Airworthiness Directive

Airworthiness Directives; BELLANCA, INCORPORATED Models 14-19-3, 14-19-3A, **17-30**, 17-31 and 17-31TC, **17-30A**, 17-31A and 17-31ATC Airplanes

AD 90-02-17

**FRONT SPAR DRAG STRUT FITTING ASSEMBLY
BELLANCA P/N 194153-10**

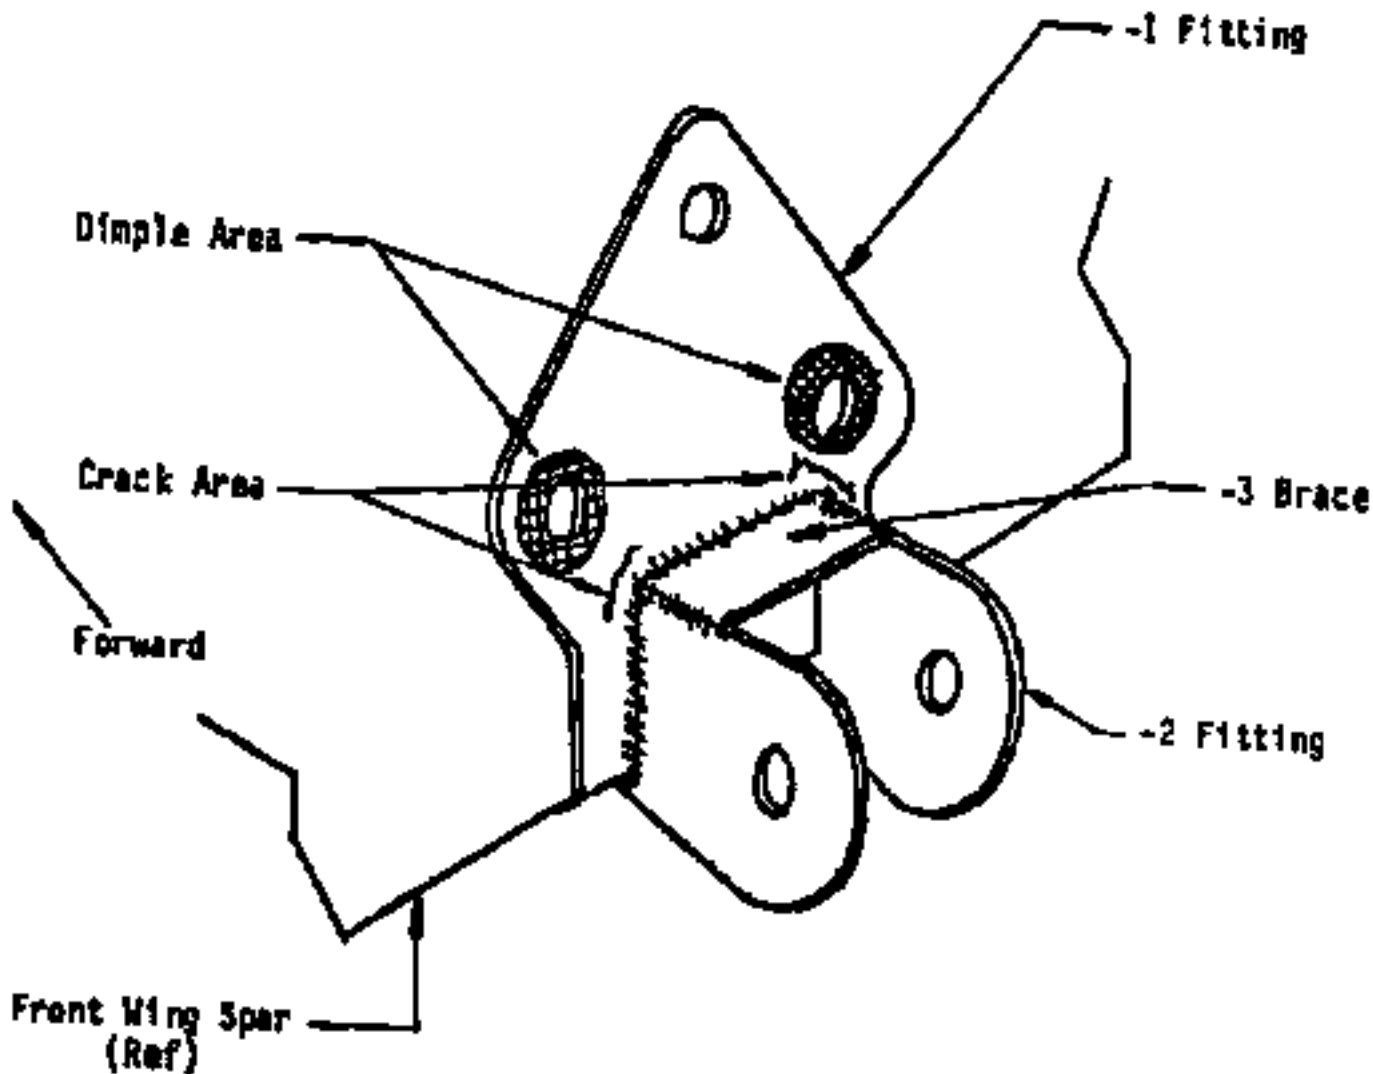
(2) Figure 1 to this AD describes the 194153-10 fitting assembly. Clean the aft face of the -1 fitting with Stoddart solvent and a brush.

(3) Inspect for cracks adjacent to the welds which join the -1 fitting to the -2 fitting and -3 brace near the lower aft attachment bolt holes using liquid penetrant inspection techniques and a magnifying glass. If any crack is found, prior to further flight replace the assembly with a new fitting assembly, P/N 194153-30 or P/N 194153-40, as applicable.

EXAMPLES OF MEASURING DEPTH OF DIMPLED AREAS

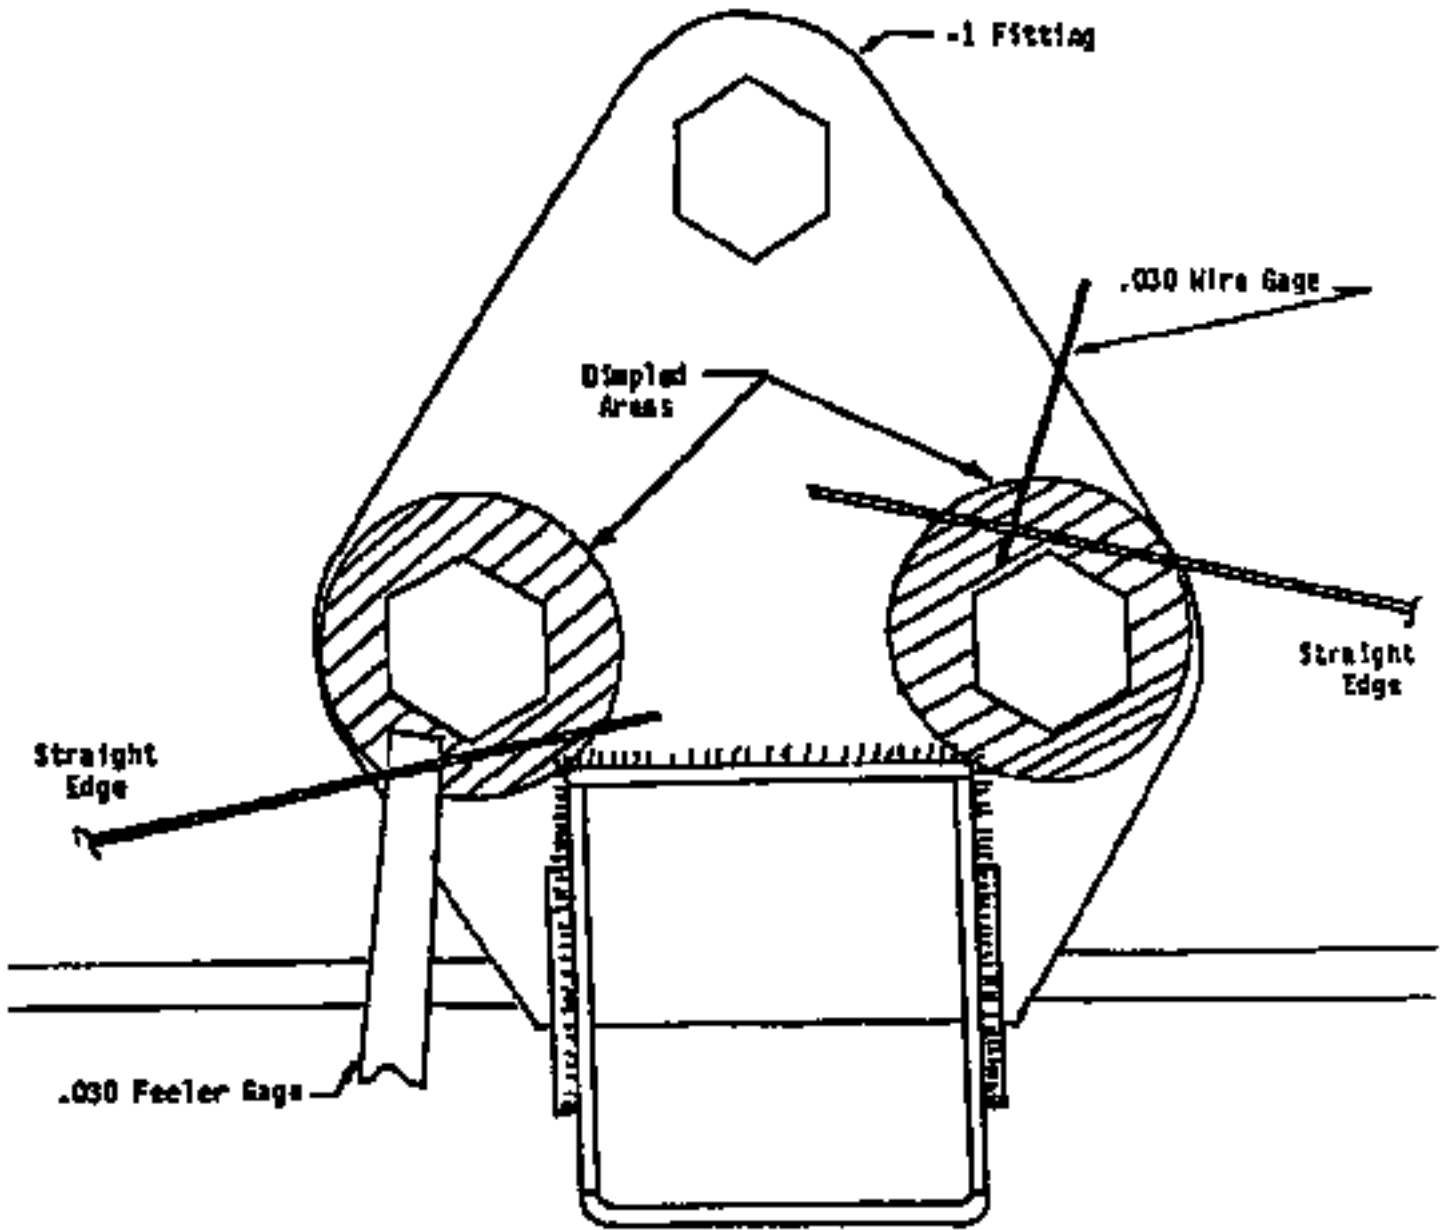
(4) Lay a straight-edge along side the lower aft attachment bolts, in accordance with Figure 2 and, using a feeler gage or wire gage of .030 inch thickness, look for any evidence of local deformation (dimpling) in the -1 fitting. If any deformation greater than .030 inches is found, prior to further flight replace the assembly with a new fitting assembly, P/N 194153-30 or P/N 194153-40, as applicable.
